ELI BRIDGE COMPANY
INCORPORATED

Wheel Bulletin No. 950317-1

Subject: Rim Cable Turnbuckle Pins

Engineering Bulletin # 950317-1

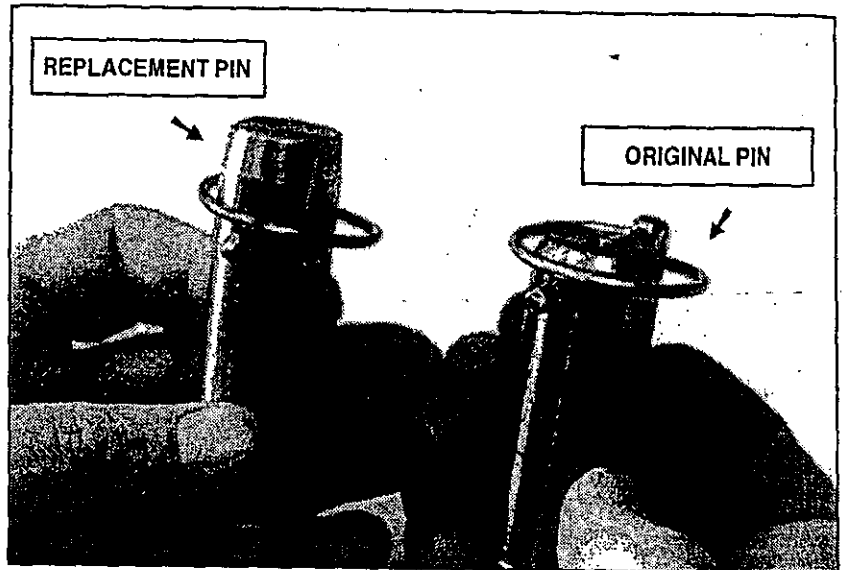
1. In the course of testing an Eagle at Eli Bridge Company a very serious problem developed with the turnbuckle pin used in the pair of rim cables which make the final connection when the Wheel is unfolded.

2. One end of the turnbuckle is permanently connected to the spoke with a bolt and self-locking nut. The other end of the turnbuckle must be disconnected every time the Wheel is folded, so that end has been fitted with a pin secured with a Klik-pin. The pin which has been used up to the present time is the pin which was supplied to us by the cable manufacturers. The hole in the pin is close to the end of the pin, and we have found that it is possible for the Klik-pin to be shoved off the pin without unlocking the Klik-pin.

3. In our testing procedure, the Eagle had been running for approximately 9.5 hours when for some reason not explainable the Klik-pin apparently worked out of the pin, the pin fell out, and the rim cable came loose.

5. We are convinced the problem was with the pin. Therefore, we have prepared a new design pin with a longer tapered end. The Klik-pin cannot be removed unless it is first unlocked by pulling open the ring.

6. Each Wheel requires two pins of this new design. We are furnishing them to you at no charge. It is imperative that you get rid of the old pins and immediately install the new ones we are sending you.

7. We consider this modification to be mandatory, immediately on receipt of the pins. The pins are in production at the present time and will be shipped to you as soon as they are available.

Picture No. 1

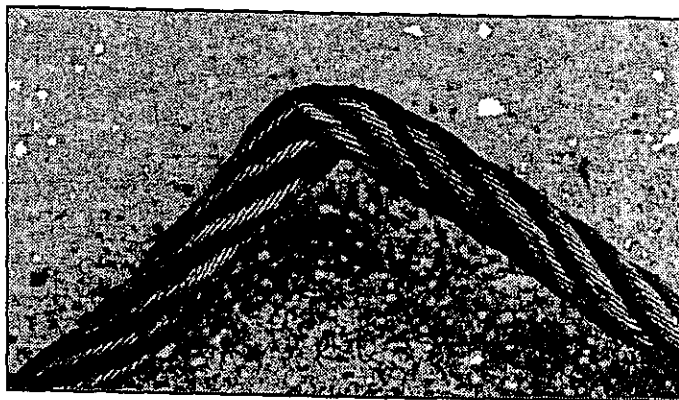
A. Kinking, as shown in Picture No. 1. Sometimes this has occurred when the winch cable has been pulled too tightly around the ends of the A-frames when folded for traveling.

Picture No. 2

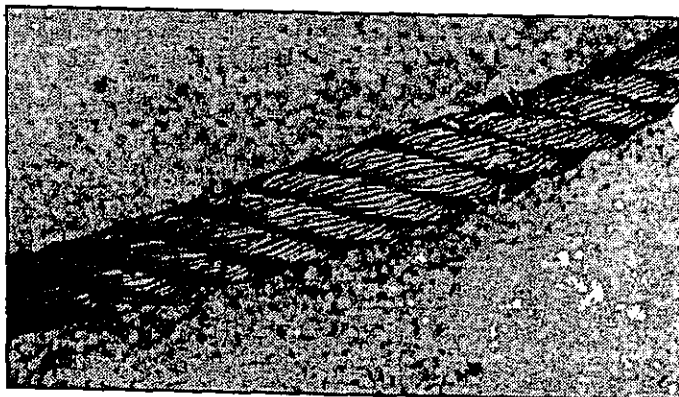
B. Crushing or flattening of the cable because it has not been wound evenly on the winch drum. See Picture No. 2.

Picture No. 3

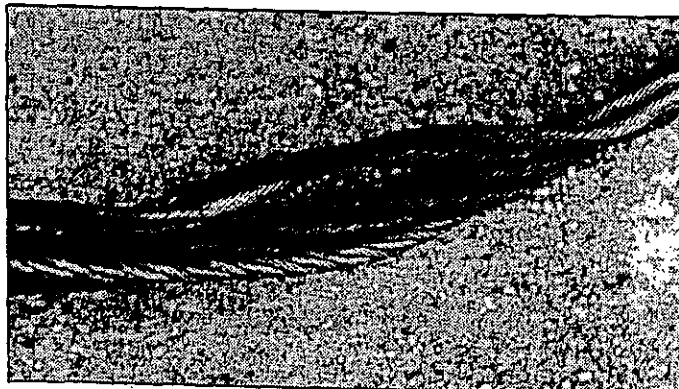
C. Bird caging, as shown in Picture No. 3, where the cable strands have expanded, leaving a "bird cage" in the middle.

Figure 1

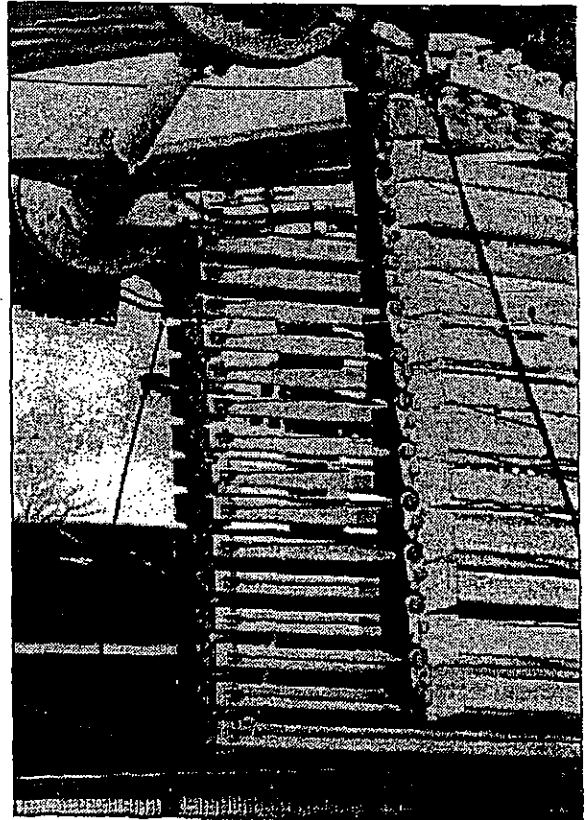
Initially inspecting for wear can be done easily with the Wheel folded for transport. The distance between the master spoke tenon and the next spoke tenon must be measured to the nearest 1/32" on each side.

Figure 2

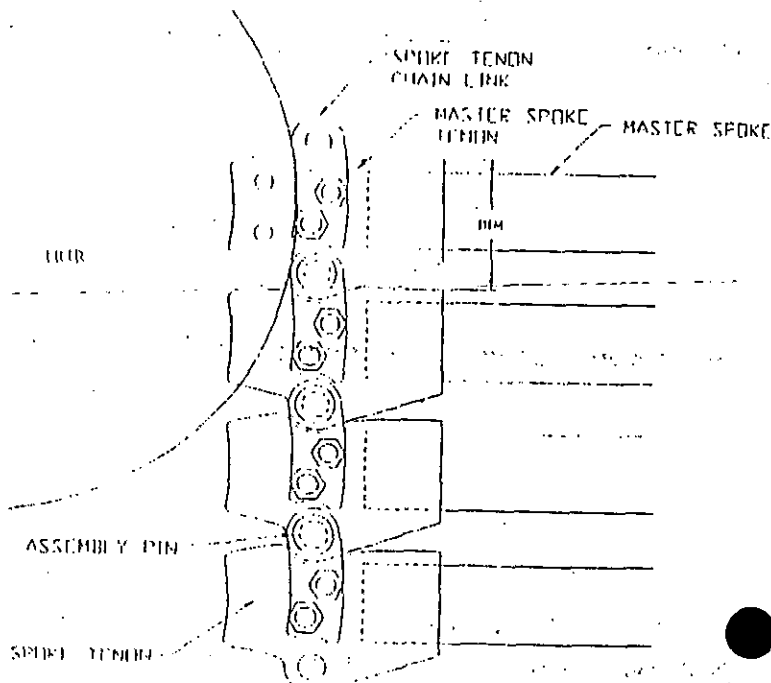
The drawing shown in Figure 2 shows where to take the measurement.

On an Eagle 16 or a Double Eagle 16, that dimension should be 5.0625" (5-1/16") to 5.125" (5-1/8").. On a HY-5 II, that dimension should be 5.15625" (5-5/32") to 5.21875" (5-7/32"). A measurement that is larger than the larger of the above dimensions indicates that the assembly pins are probably worn and require further inspection.

Figure 3

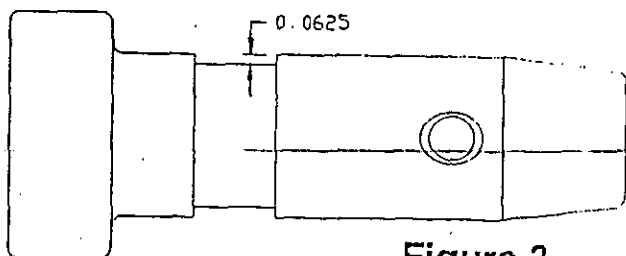
With the nuts loosened, pry the spoke tenon chain link on the inside of the Wheel back away from the spoke tenon enough so that the assembly pin can be seen where the spoke tenon bears against it. A worn pin will have a smaller diameter where the spoke tenon makes contact with it. The original equipment pin is one inch in diameter. If you can see that any part of the pin is worn by .0625" (1/16") as shown in Figure 3, the pin must be replaced. Be sure to retighten the nuts on each spoke tenon chain link before loosening the nuts on the next one to be inspected.

If the pin holes in the spoke tenon chain link or the spoke tenon have elongated .0625" (1/16") to a total length of 1.0625" (1-1/16"), then the spoke tenon chain links and the spoke tenon should be aligned as closely as possible and then reamed out to a diameter of 1.0625" (1-1/16"). Then an oversize pin should be installed.
